S4.55 AMENDMENTS:

PROJECT
TWO SEMI-DETACHED DWELLINGS
WITH BASEMENT CARPARKING;
52 LAUDERDALE AVENUE,
FAIRLIGHT, NSW
CLIENT
DAVID ALLEN & THE CASEY FAMILY TRUST

NUMBER
A0.02
REVISION
MOD2

DRAWING TITLE		PROJECT	
UNDERCROFT FLOOR PLAN		LAF	
SCALE	STATUS	NUMBER	REVISION
1"=100 @A3	s4.55	A1.02	MOD2

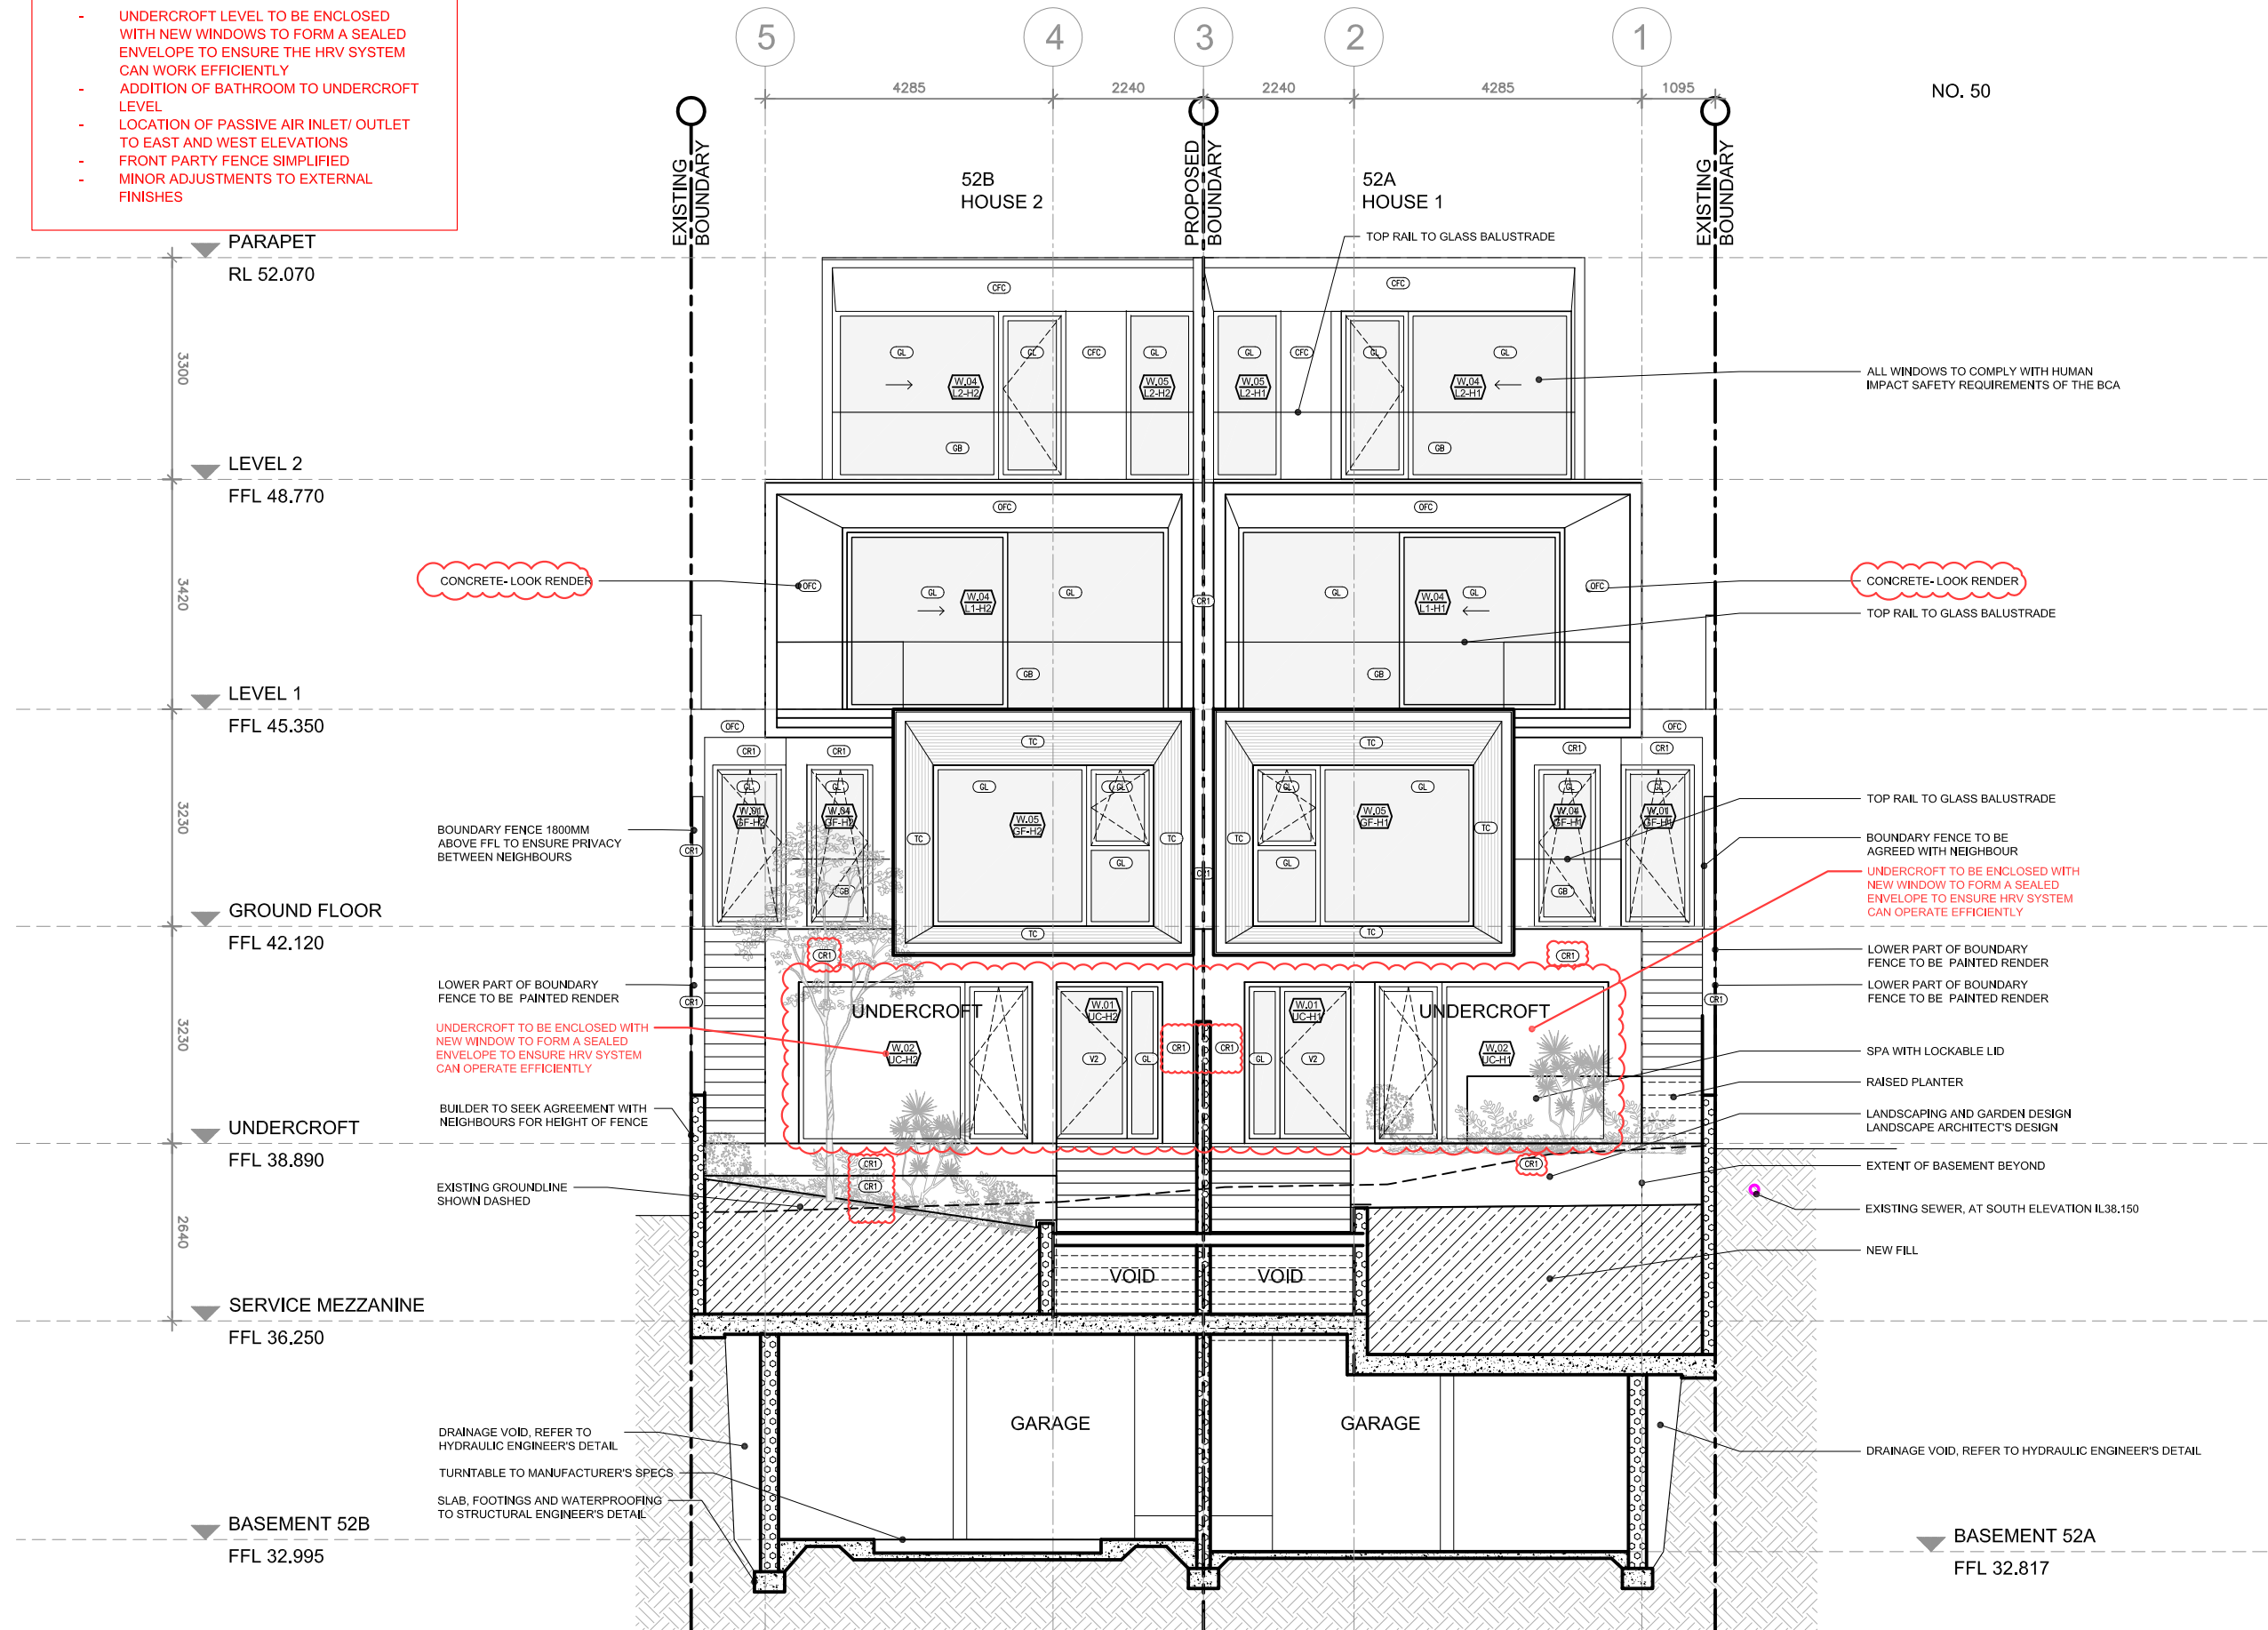
- UNDERCROFT LEVEL TO BE ENCLOSED WITH NEW WINDOWS TO FORM A SEALED ENVELOPE TO ENSURE THE HRV SYSTEM CAN WORK EFFICIENTLY
- ADDITION OF BATHROOM TO UNDERCROFT LEVEL
- LOCATION OF PASSIVE AIR INLET/ OUTLET TO EAST AND WEST ELEVATIONS
- FRONT PARTY FENCE SIMPLIFIED
- MINOR ADJUSTMENTS TO EXTERNAL FINISHES

DRAWING TITLE	STATUS	NUMBER	REVISION	PROJECT
WEST ELEVATION				LAF
SCALE				
1:100 @A3	S4.55	A2.02	MOD 2

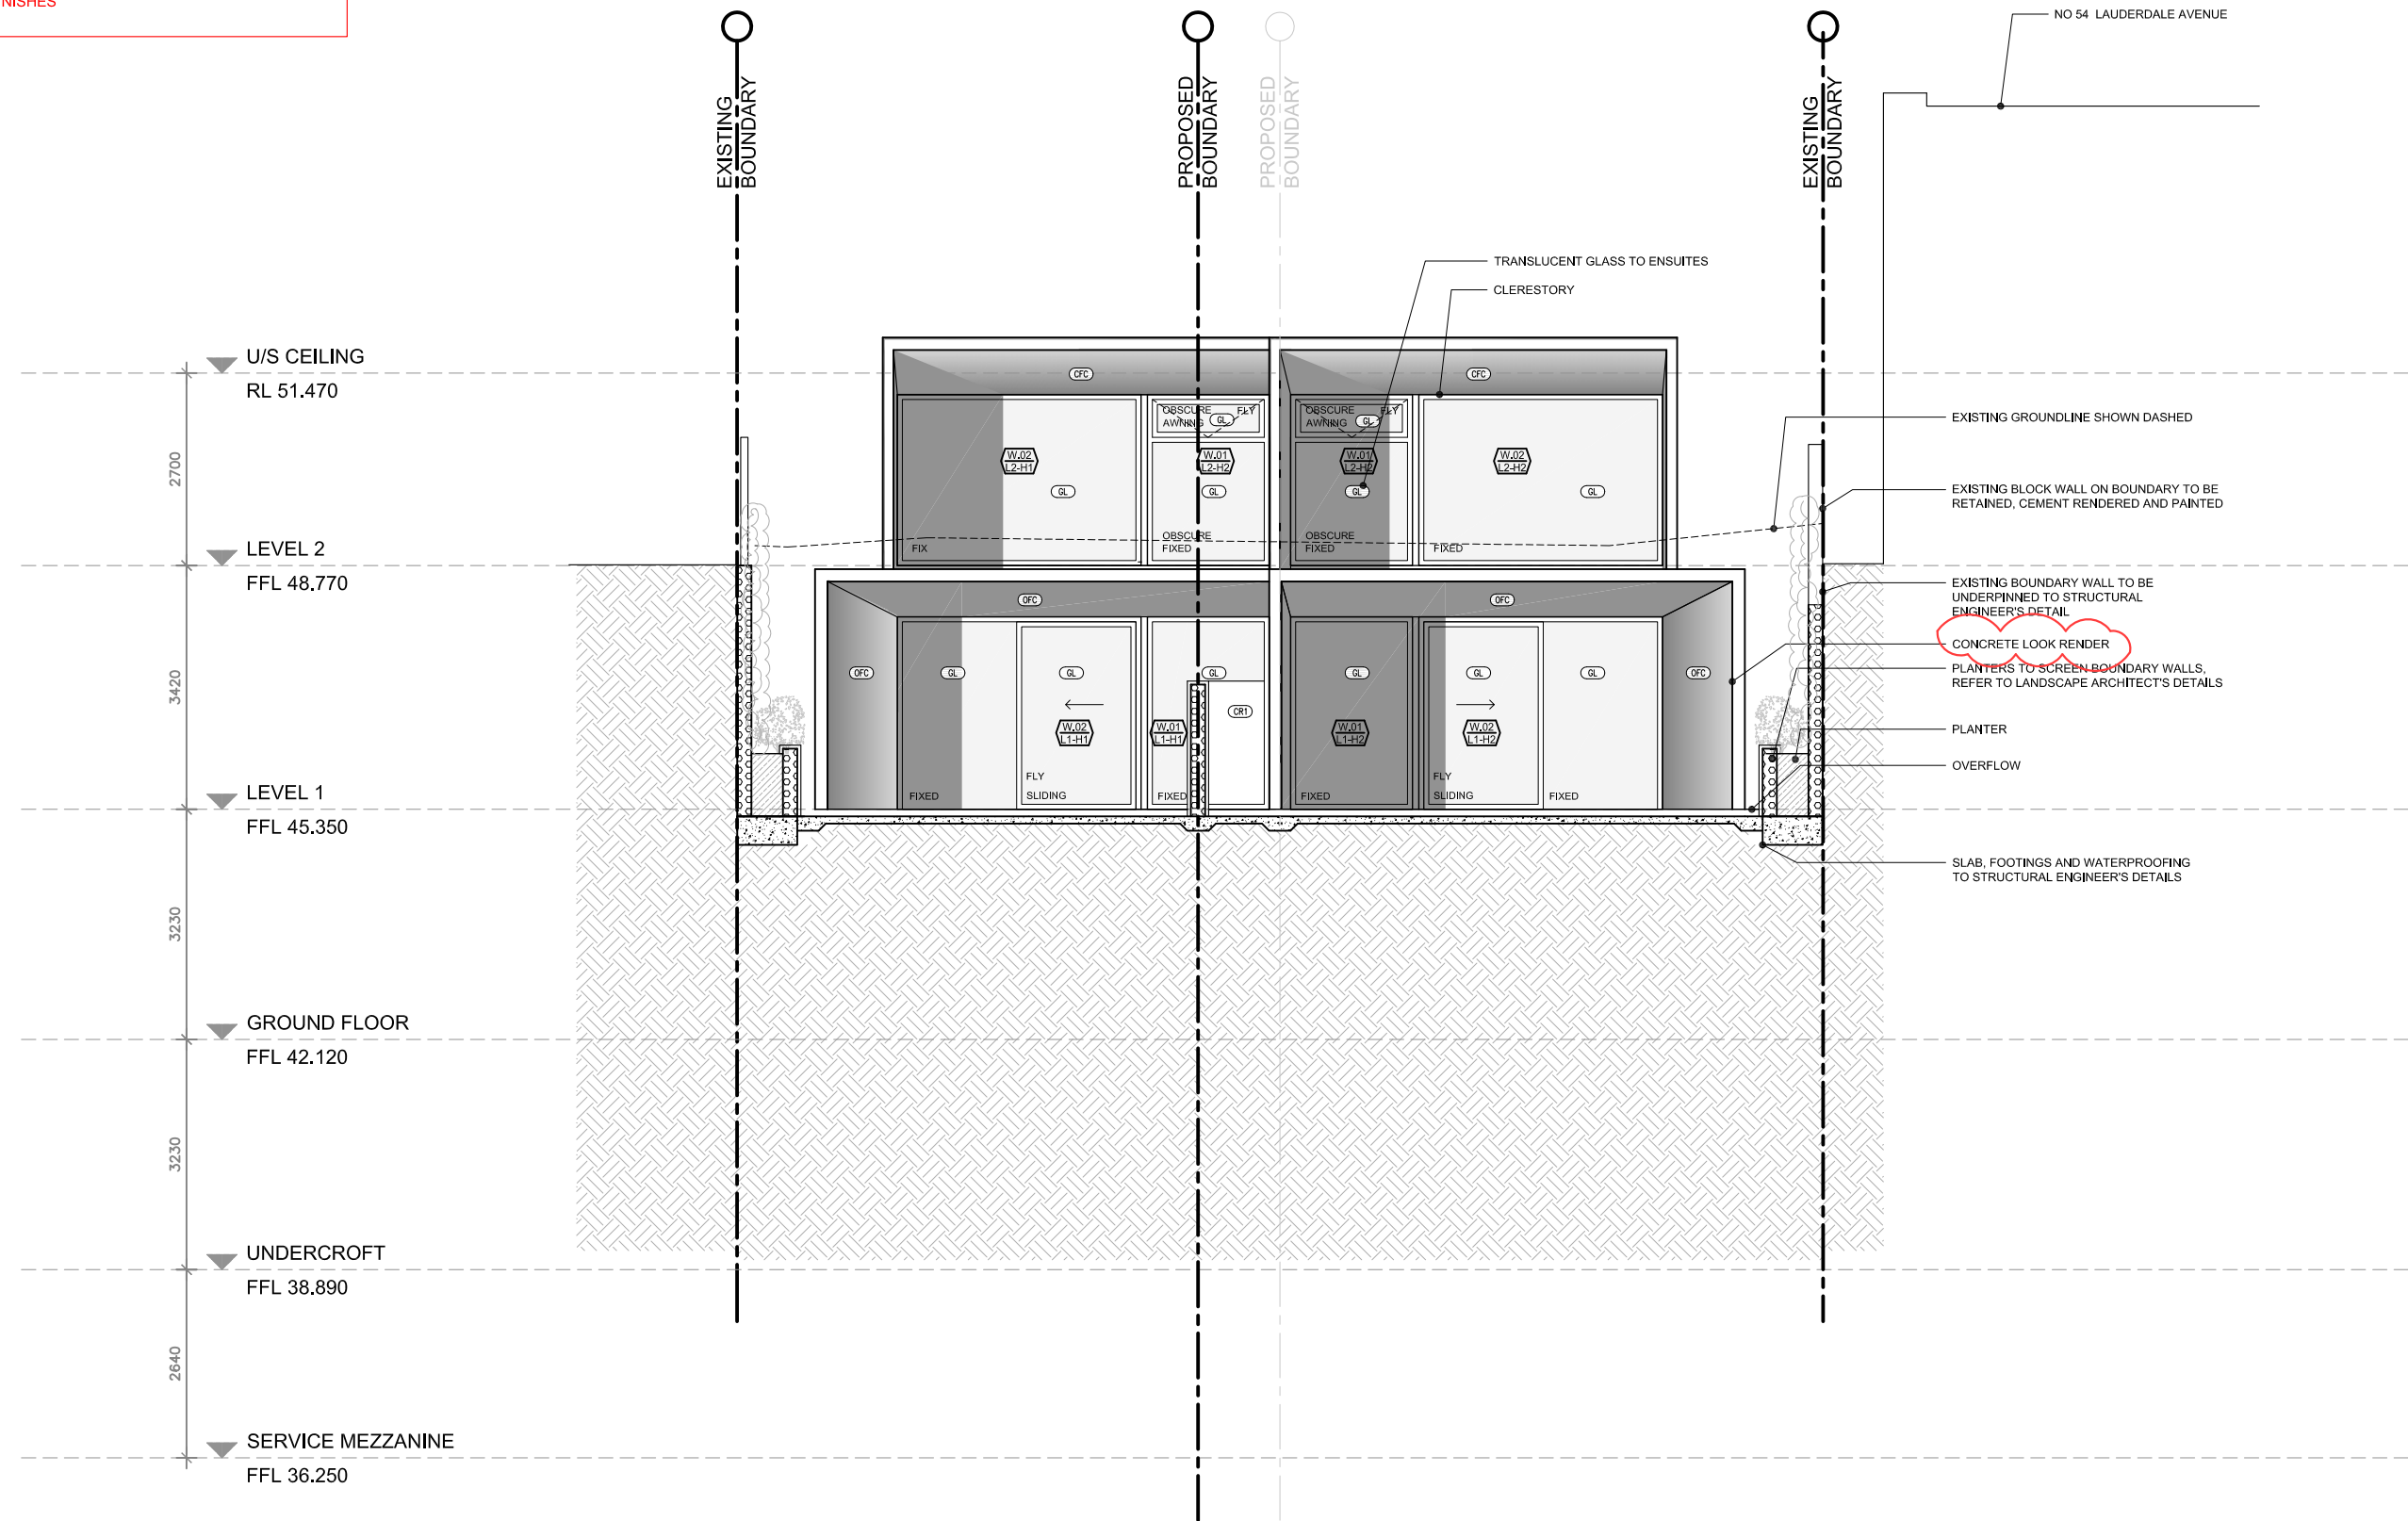
- UNDERCROFT LEVEL TO BE ENCLOSED WITH NEW WINDOWS TO FORM A SEALED ENVELOPE TO ENSURE THE HRV SYSTEM CAN WORK EFFICIENTLY
- ADDITION OF BATHROOM TO UNDERCROFT LEVEL
- LOCATION OF PASSIVE AIR INLET/ OUTLET TO EAST AND WEST ELEVATIONS
- FRONT PARTY FENCE SIMPLIFIED
- MINOR ADJUSTMENTS TO EXTERNAL FINISHES

EAST ELEVATION

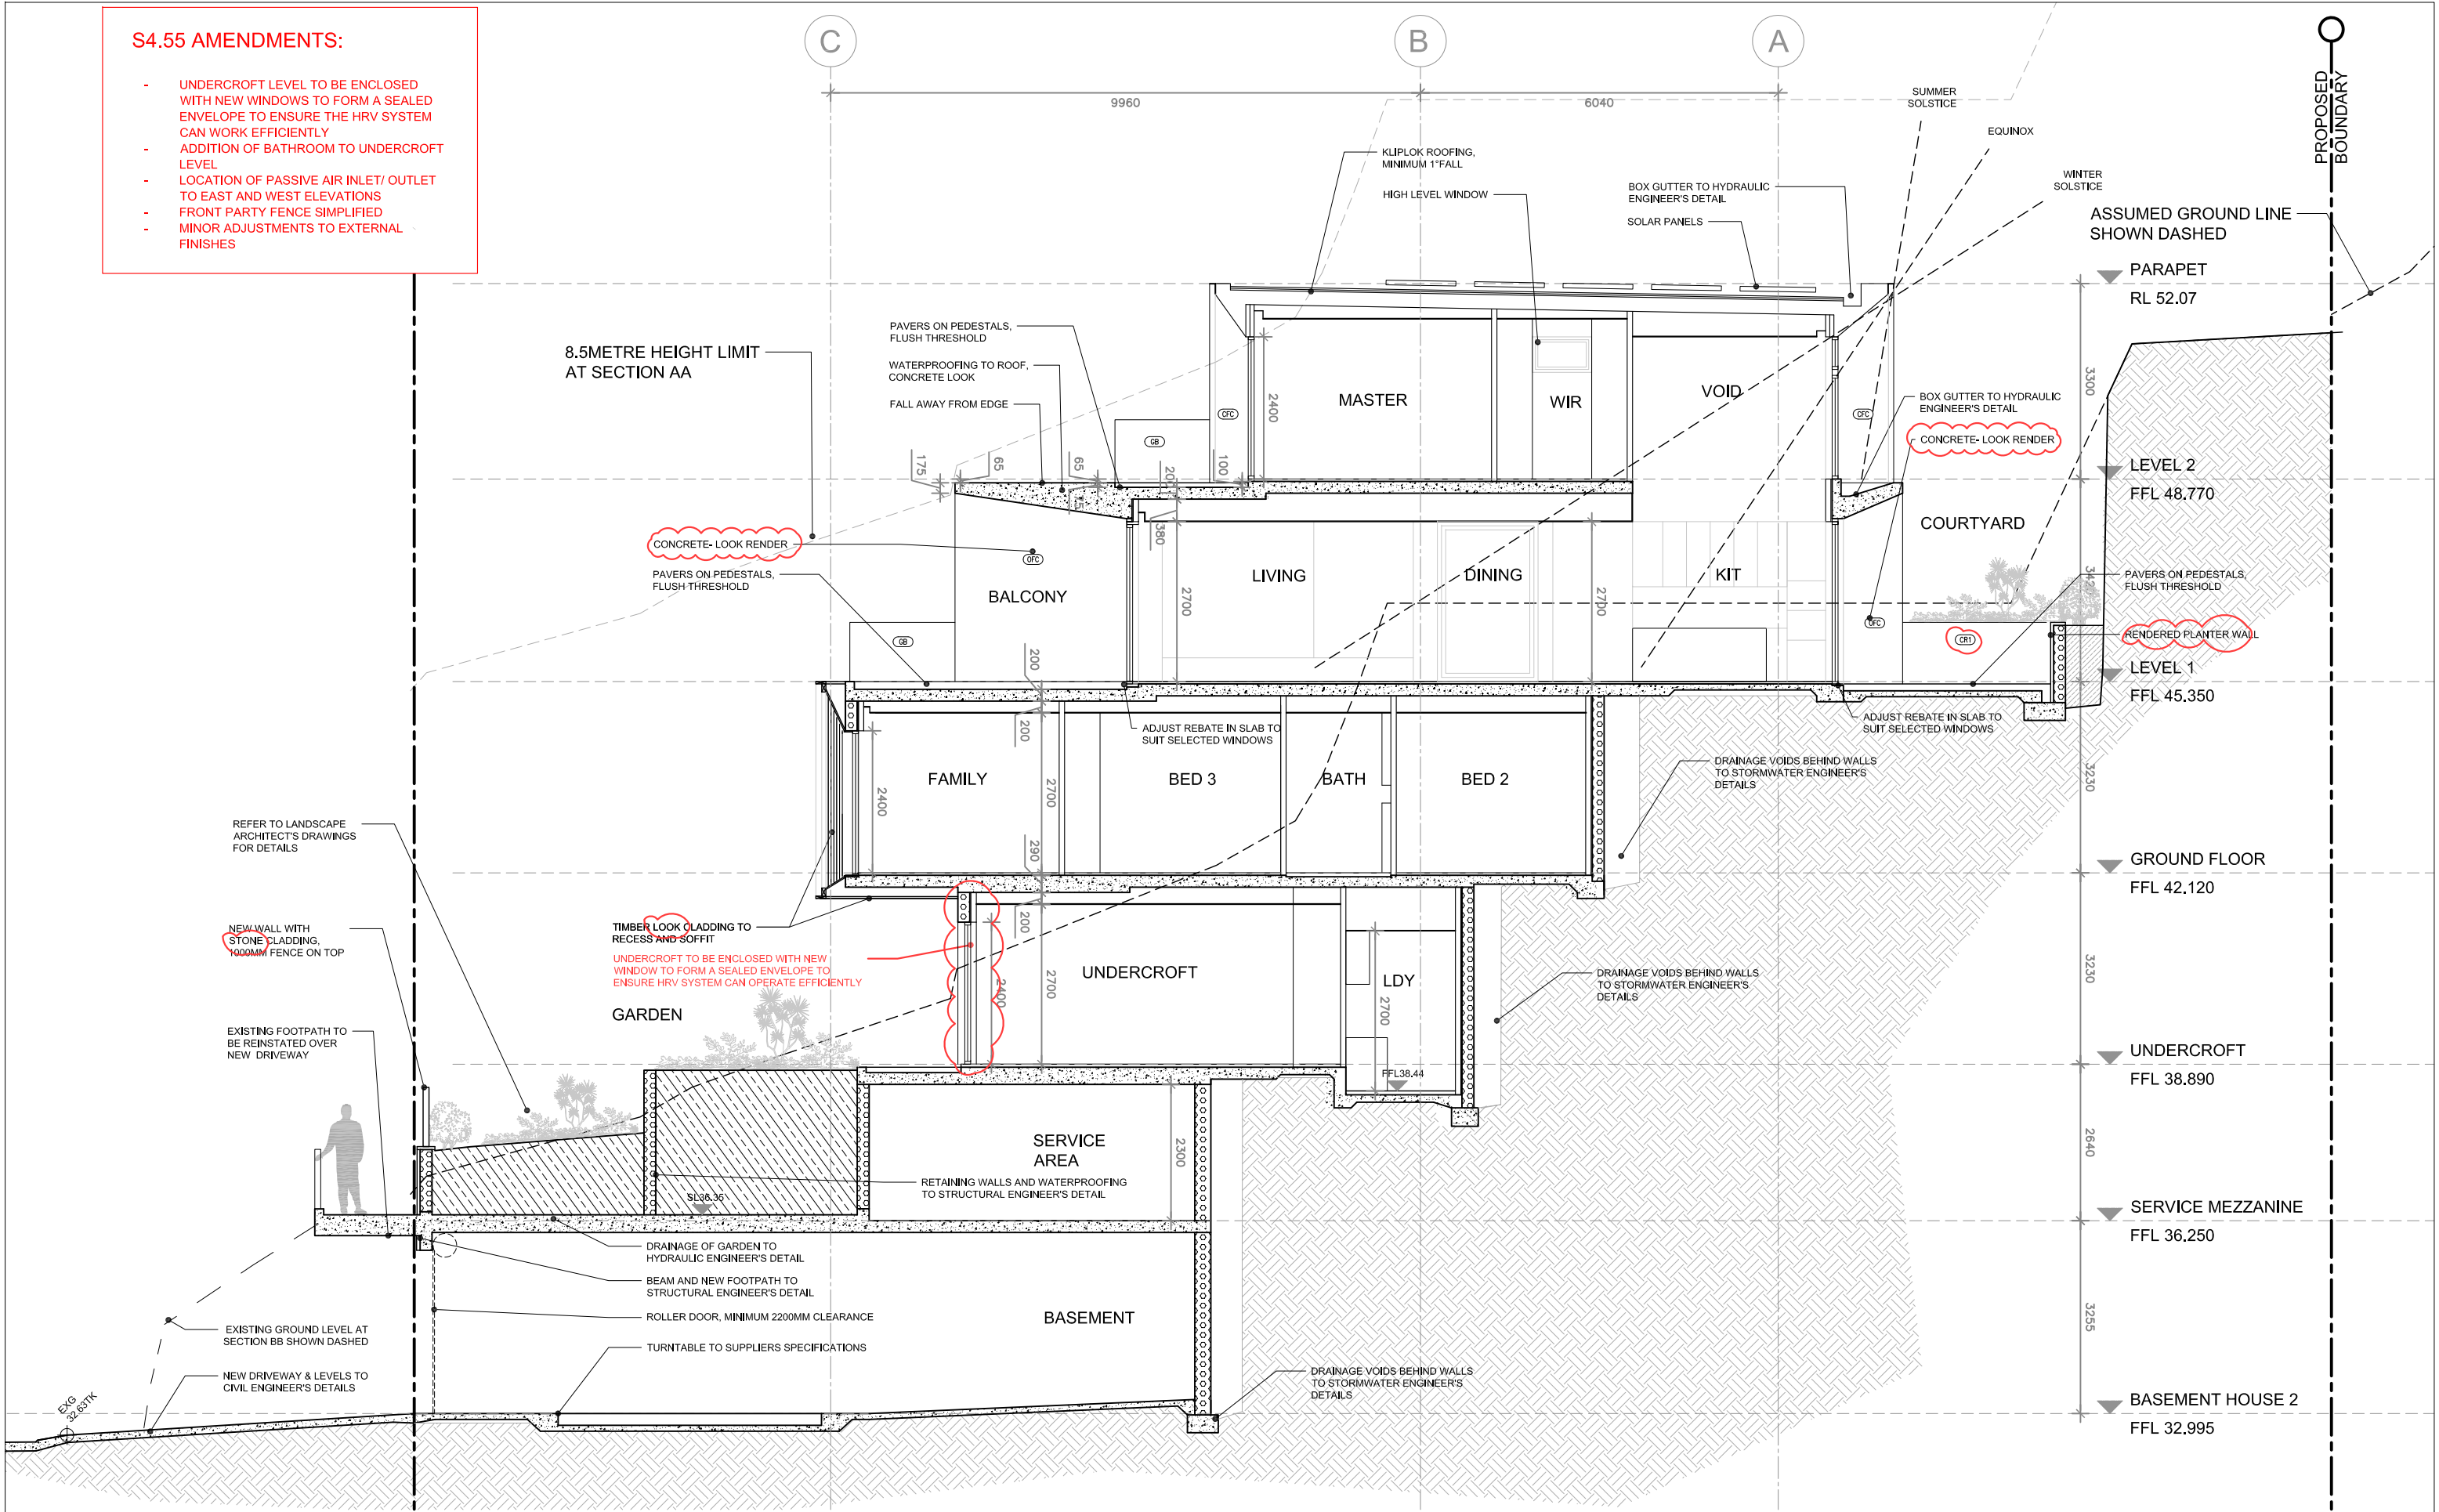
- UNDERCROFT LEVEL TO BE ENCLOSED WITH NEW WINDOWS TO FORM A SEALED ENVELOPE TO ENSURE THE HRV SYSTEM CAN WORK EFFICIENTLY
- ADDITION OF BATHROOM TO UNDERCROFT LEVEL
- LOCATION OF PASSIVE AIR INLET/ OUTLET TO EAST AND WEST ELEVATIONS
- FRONT PARTY FENCE SIMPLIFIED
- MINOR ADJUSTMENTS TO EXTERNAL FINISHES
